MEMORANDUM

To: The Design Advisory Board
From: Mary O'Neil, AICP, Senior Planner
RE: ZP 14-0784SP 247-249 Pearl Street
Date: March 11, 2014

File: ZP 14-0784SP
Location: 247-249 Pearl
Zone: RH **Ward:** 2
Date application accepted: February 26, 2014
Applicant/ Owner: Redstone / Brian Shuman
Request: Sketch Plan review of proposed redevelopment to include three story residential building with 29 residential units and surface parking to the east and south.

DATE: FEB., 2014
 SCALE: 1" = 20'
 PROJ. NO. 14103.01
 DRAWING NUMBER: **C1.1**

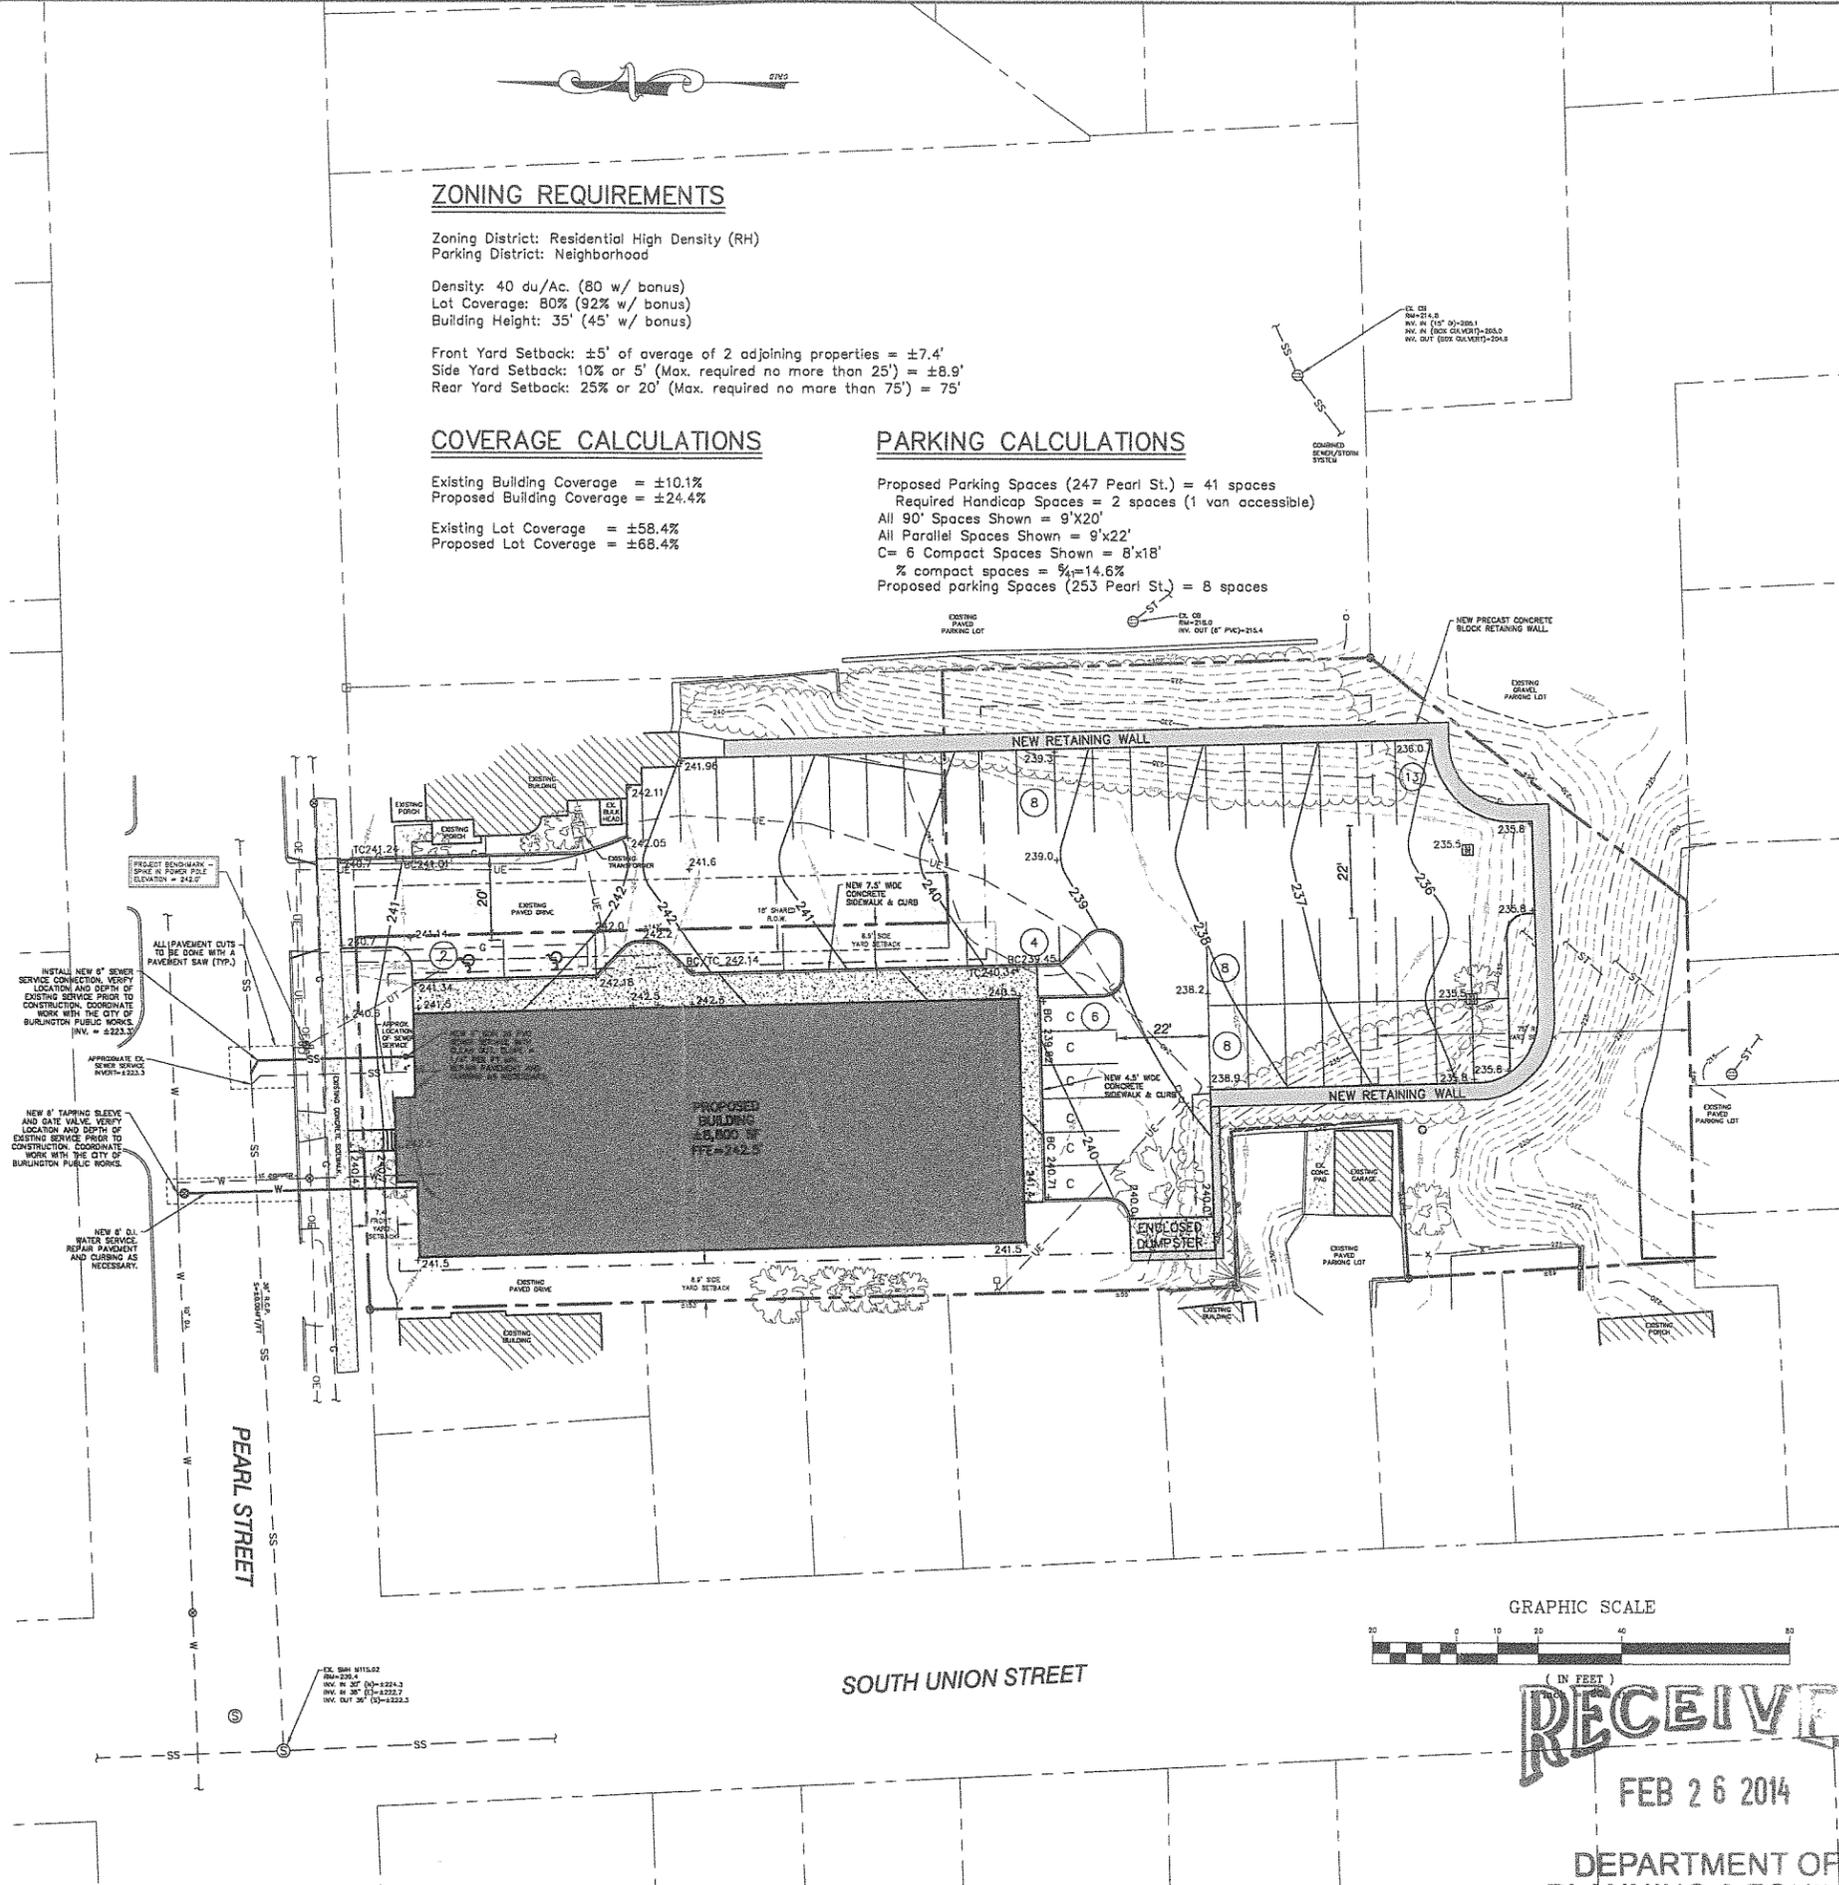
Some grading changes are proposed for the parking lot area; beginning the grade slope sooner than exists today and abutting the plan with a significant retaining wall, height or width undetermined. The wall will be required to meet the approval of the city engineer per this standard.

An area for snow storage (or a plan for snow removal) is not identified on the submitted project site plan and will be required.

The curb cut appears to be located at the same location as the previous arrangement; just east of this property boundary, and shared with 253-255 Pearl Street. Any alterations or additions to that parcel will require a separate zoning permit.

The principle entrance on Pearl Street may be accessed directly off the public sidewalk. The easterly entrance is accompanied for a 7'6" wide sidewalk with a bump-out that will separate vehicles and residential pedestrians. Unfortunately, this appears to be under several scuppers that are likely to dump roofwater on the sidewalk. The applicant shall confirm, and correct as necessary.

Parking is proposed similar to the previous parking plan, however further encroachment into the easterly bank is illustrated, with cars proposed to be parked on spaces that are no longer level and in fact "fall away" to the east and south. A retaining wall is proposed which would be an effective parking barrier; however the anticipated height and other particulars have not been submitted.

The expanded parking on the east appears to utilize what is now existing landscaping on a steep slope. The applicant will need to define the methods intended to achieve this.

Parking is laid out in a manner that includes tandem parking spaces. The project will be required to comply with Sec. 8.1.14. (*All parking facilities shall be designed to so that each motor vehicle may proceed to and from the parking space provided for it without the moving of any other motor vehicle.*) Presumably the plan may be for each pair to be dedicated to a single unit to allow for tenant-driven valet service for the movement of vehicles; however the second row of parking spaces may not count toward the parking requirement.

6 compact parking spaces are illustrated on the immediate south area of the building. It will be problematic if a full size vehicle utilizes those spaces (only 8' x 18'), as trash haulers will not be able to access the dumpster pad. Also, it is unlikely that the westerly most space will have adequate turn-around. (20' required by Table 8.1.11-1.)

The plan will be required to provide 8 trees meeting the above specified minimum caliper to meet the shading standard ($41 / 5 = 8.2$.) A landscaping plan will be required.

A sidewalk is provided along the easterly side of the building...although it threatens to be the victim of active rooftop scuppers in inclement weather. Protection from this event will need to be planned and incorporated into the design.

Only a dumpster, abutting the retaining wall is identified on the site plan. This dumpster is proposed to be approximately 10' above the immediately abutting single family property to the west. Some landscaping to soften that transition is in order.
